**SUBDIVISION REVIEW SHEET****CASE NO.:** C8-2019-0057.2A**COMMISSION DATE:** January 10, 2023**SUBDIVISION NAME:** Pearson Ranch West Phase 2 Final Plat**ADDRESS:** 14400 N FM 620 Road**APPLICANT:** Brett Ames (Pearson Ranch, LLC)**AGENT:** Vanessa Mendez (Dunaway Associates)**AREA:** 58.65 acres**LOTS:** 11**COUNTY:** Williamson**JURISDICTION:** 2-Mile ETJ**WATERSHED:** Lake Creek

CITY OF AUSTIN –DEVELOPMENT SERVICES DEPARTMENT  
SUBDIVISION APPLICATION – MASTER COMMENT REPORT

CASE NUMBER: C8-2019-0057.2A  
UPDATE: U0  
CASE MANAGER: Joey de la Garza      PHONE #: 512-974-2664

PROJECT NAME: Pearson Ranch Phase 2A Final Plat  
LOCATION: 14320 N FM 620 RD SB

FINAL PLAT  
PEARSON RANCH WEST  
PHASE 2

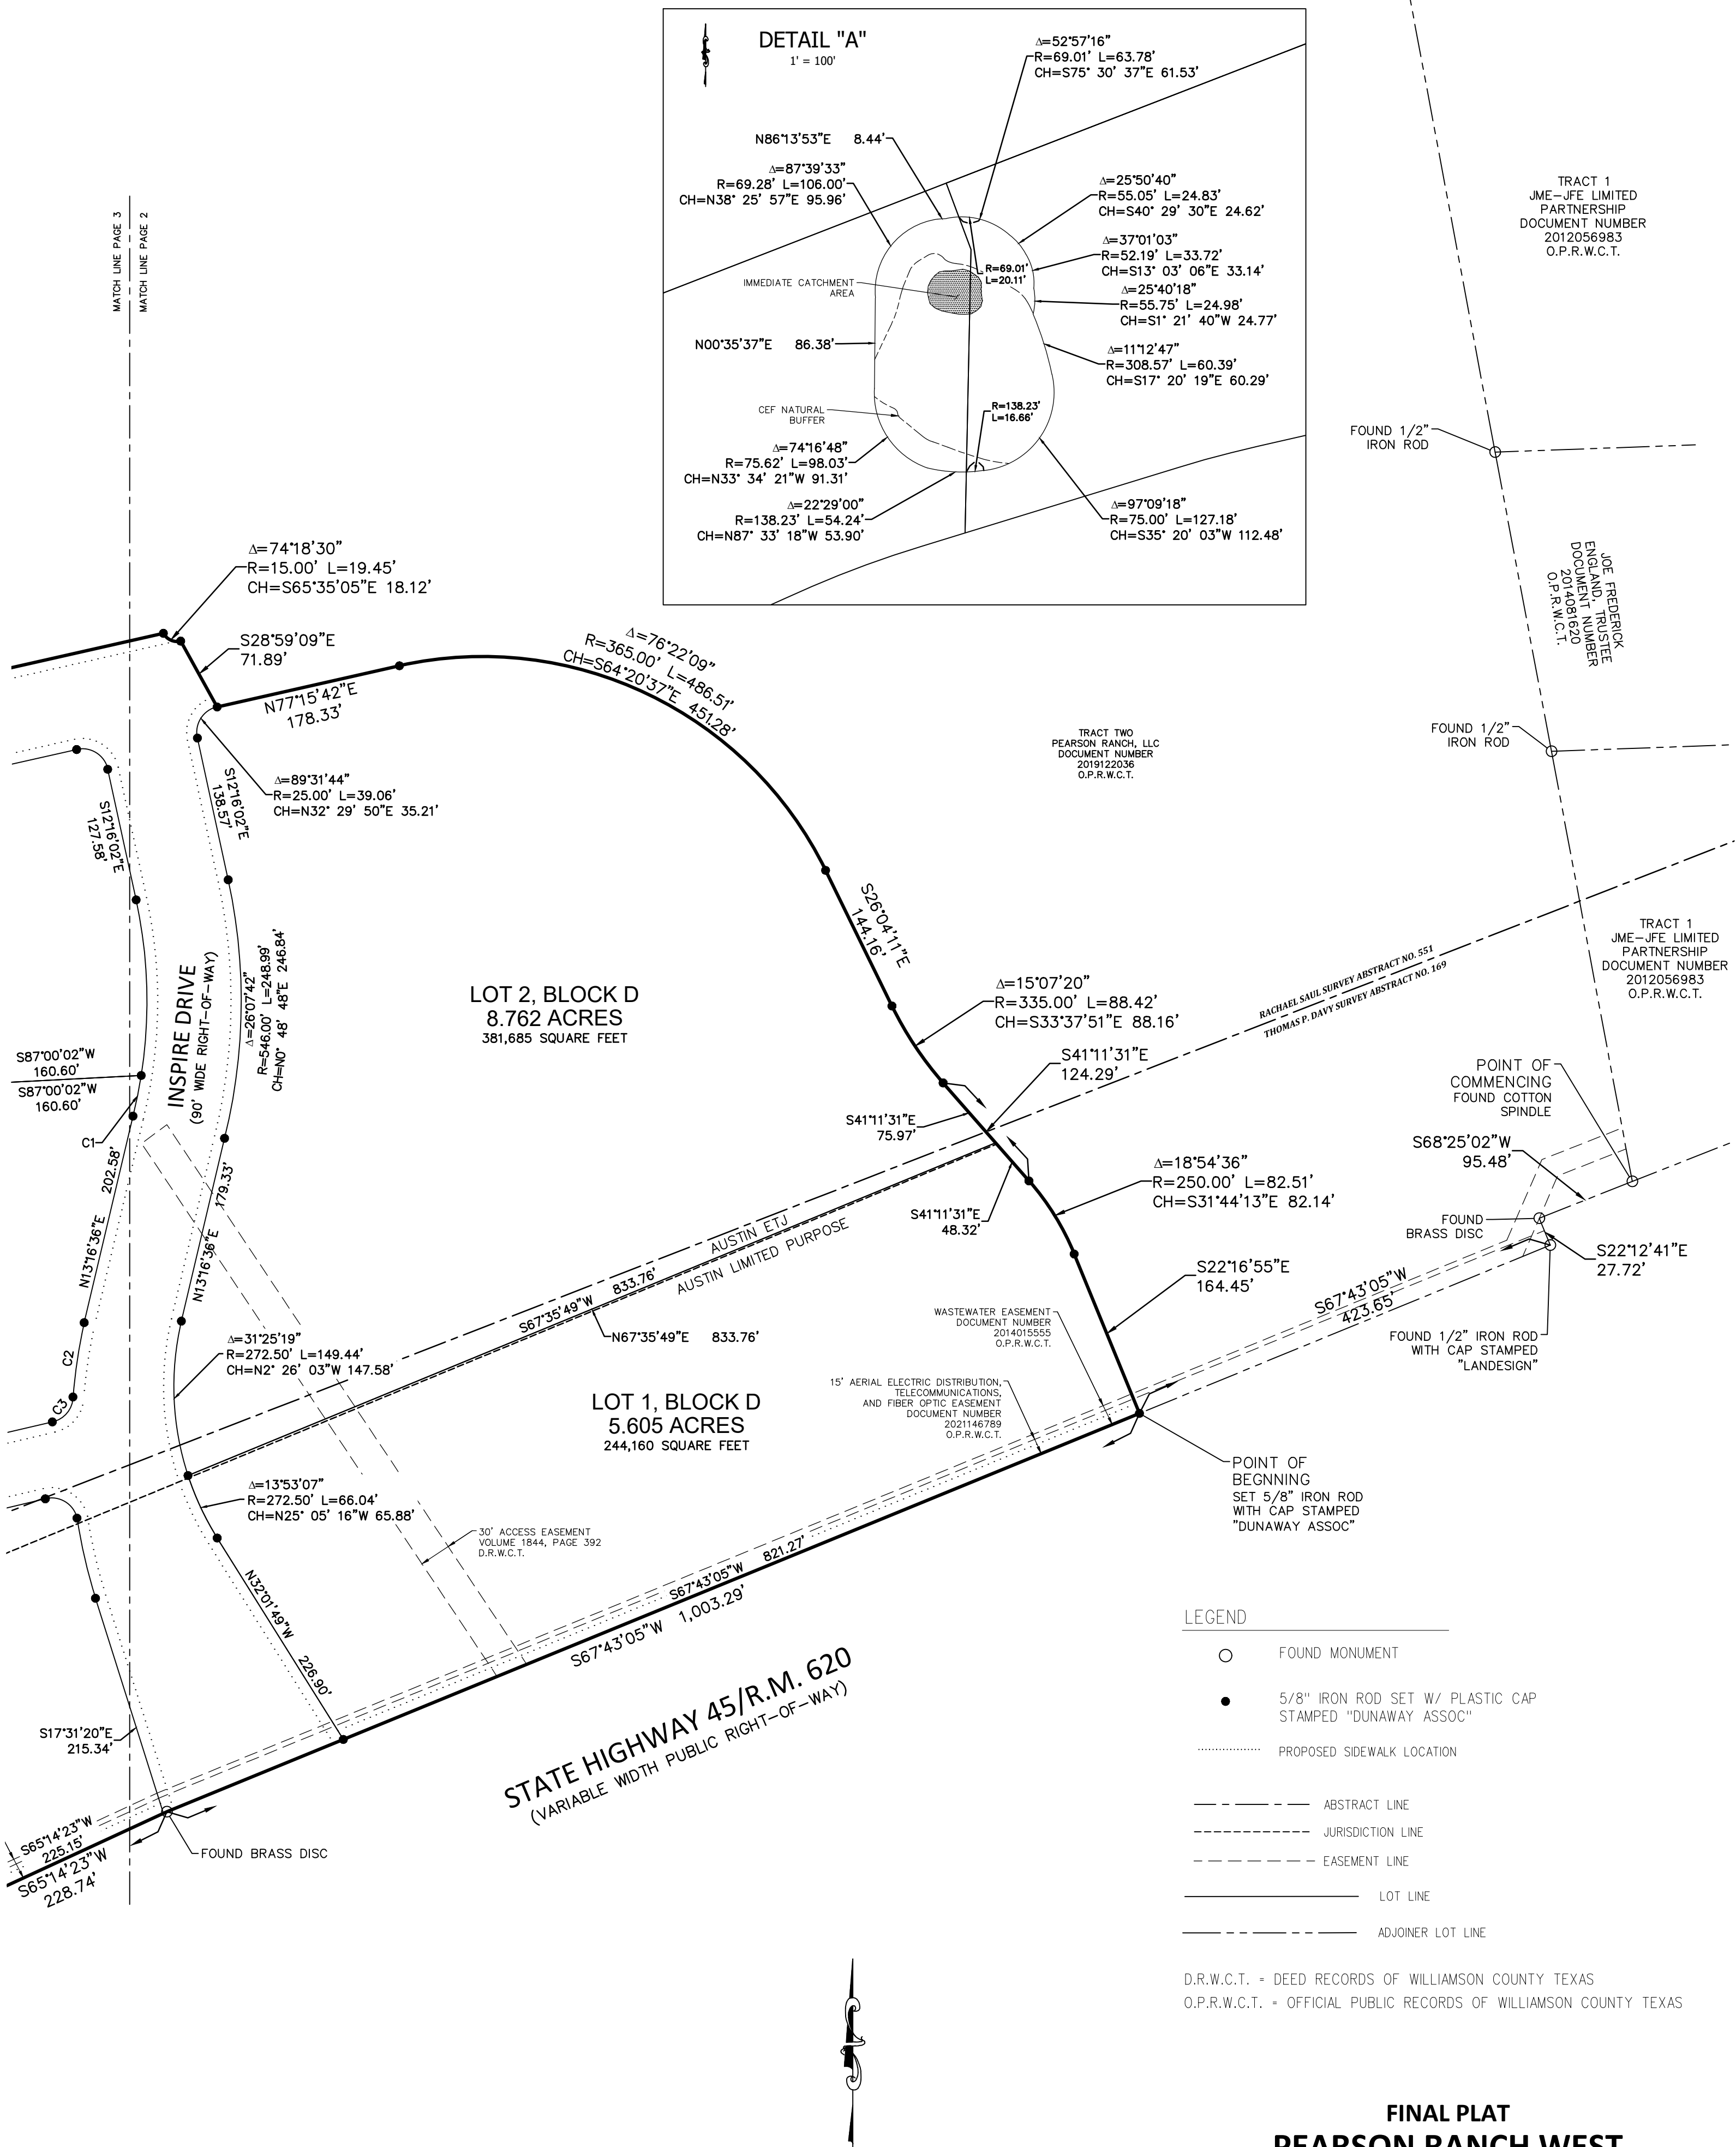
NOTE: BANKS ST is incorrectly labeled as BANK ST on all sheets.

**FINAL PLAT  
PEARSON RANCH WEST  
PHASE 2**

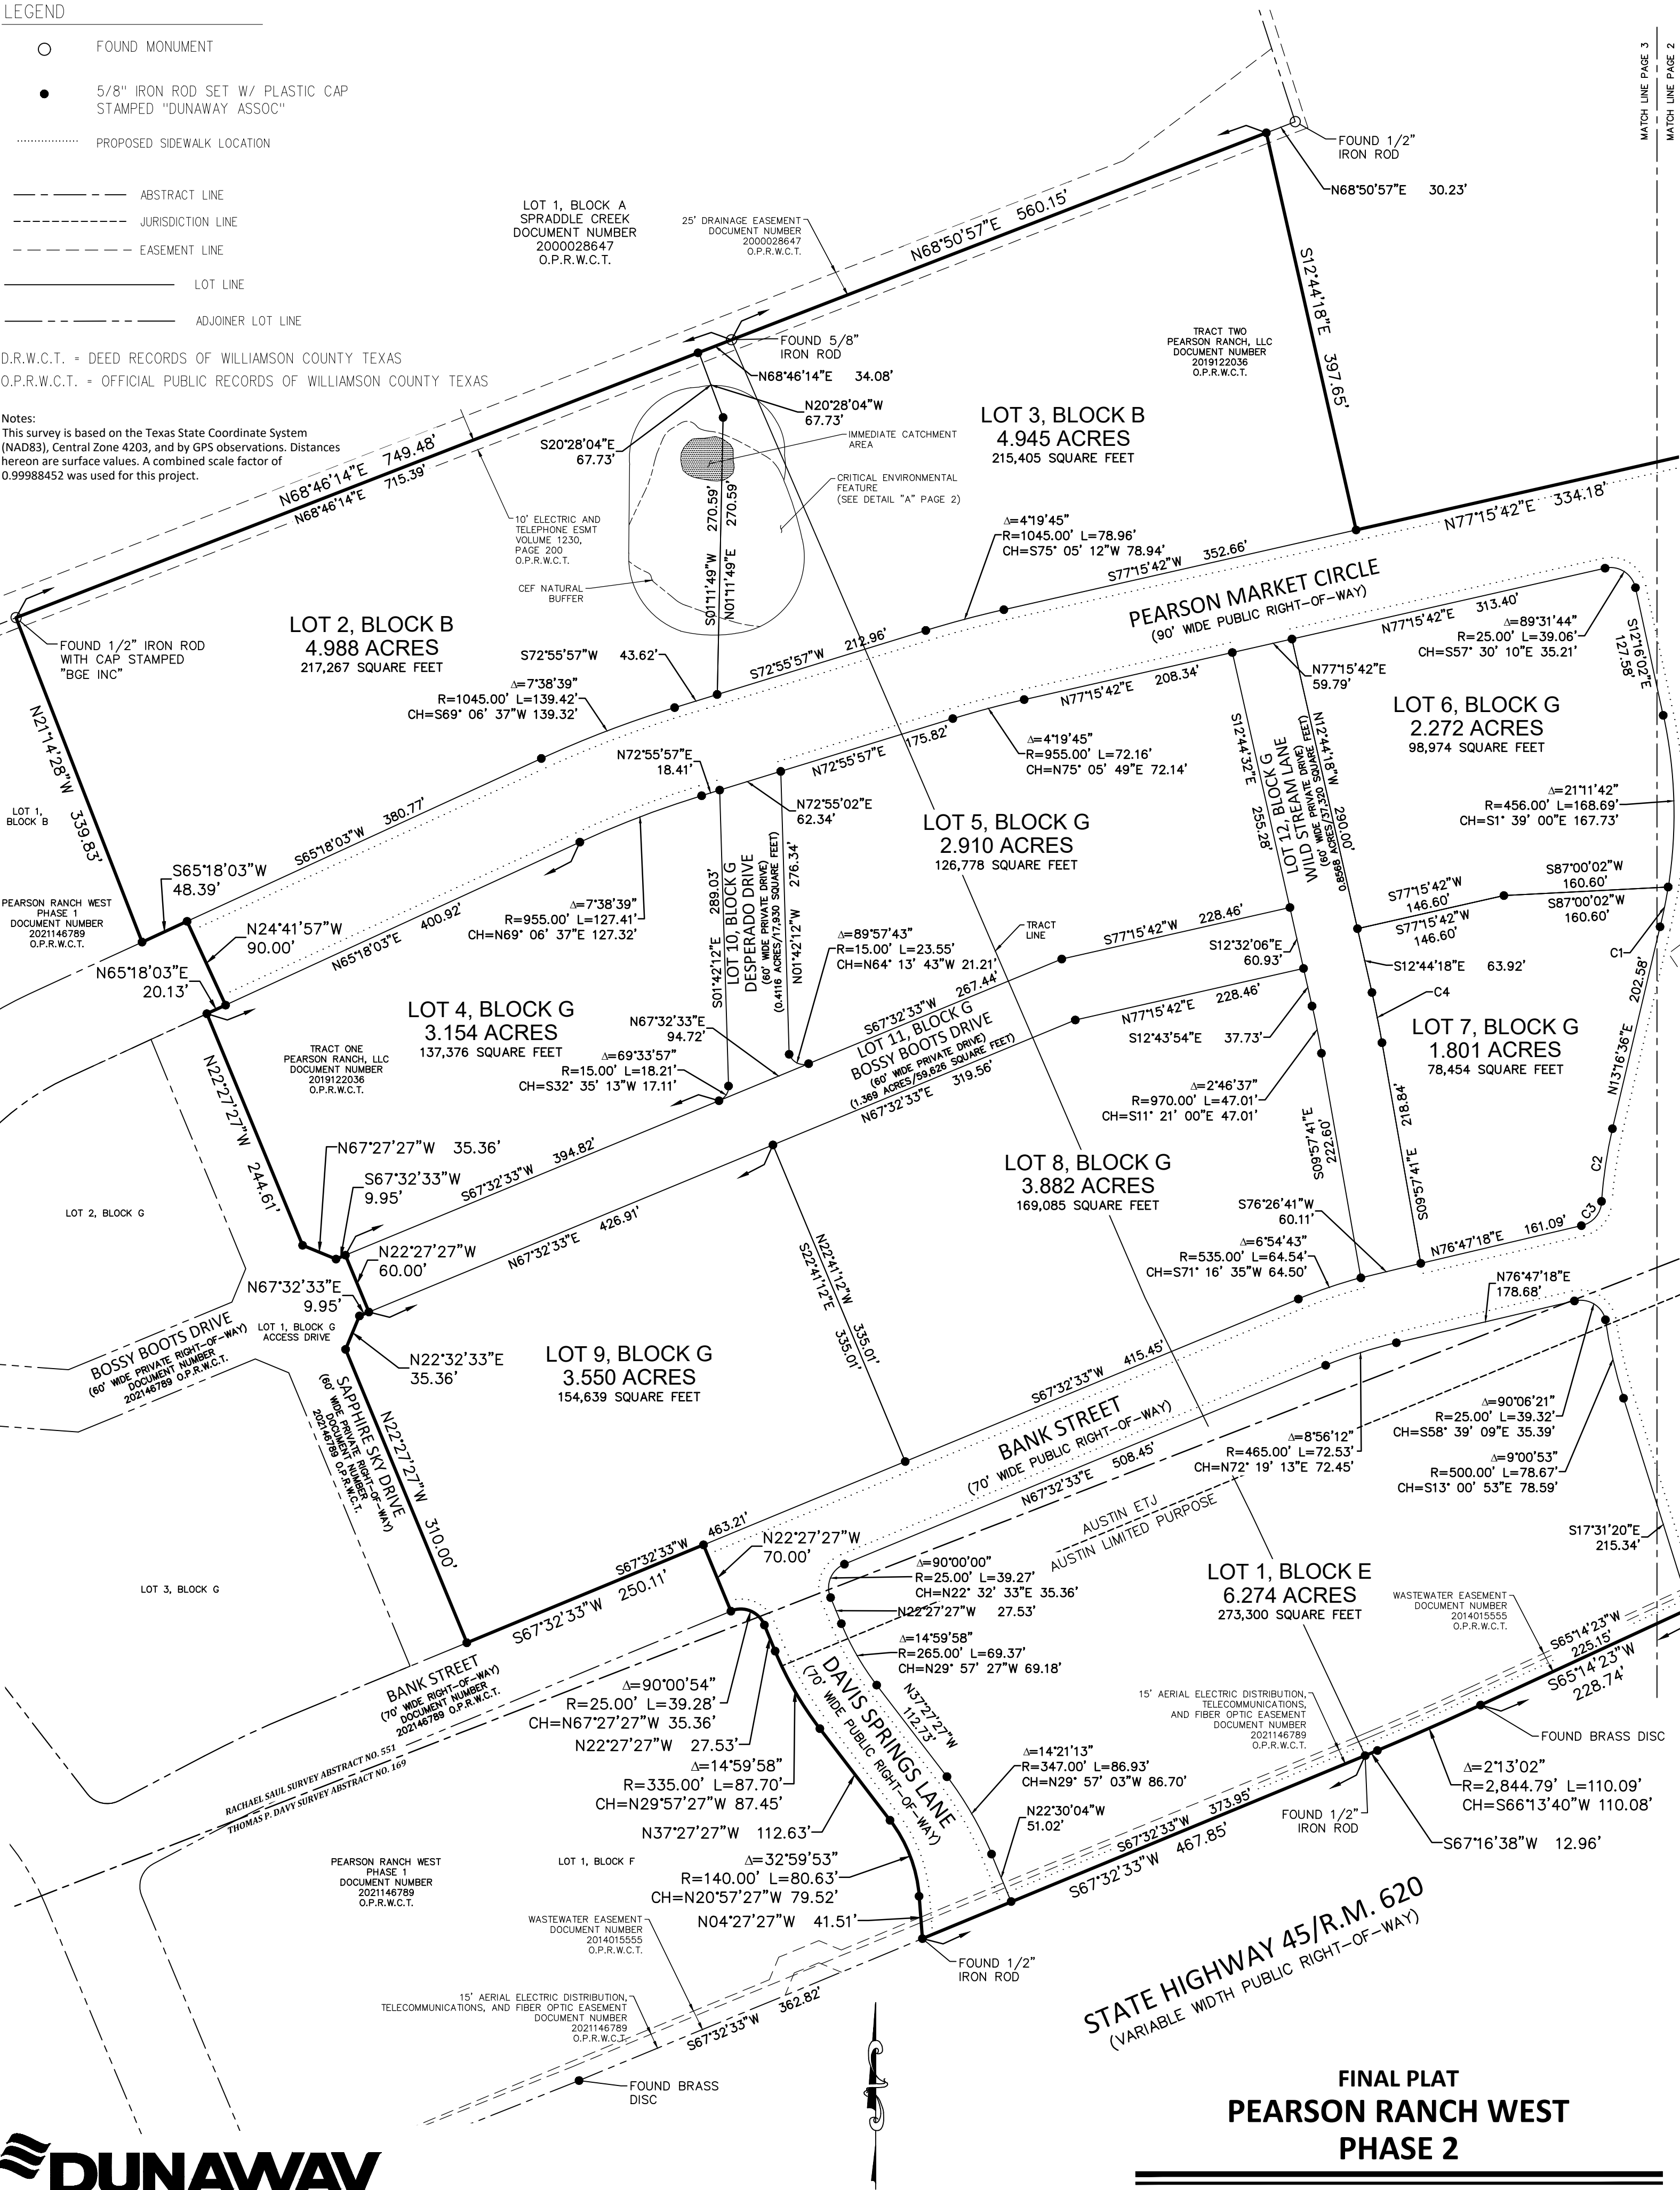
- PR 4: To demonstrate compliance, revise note 28 to the following note to the plat:
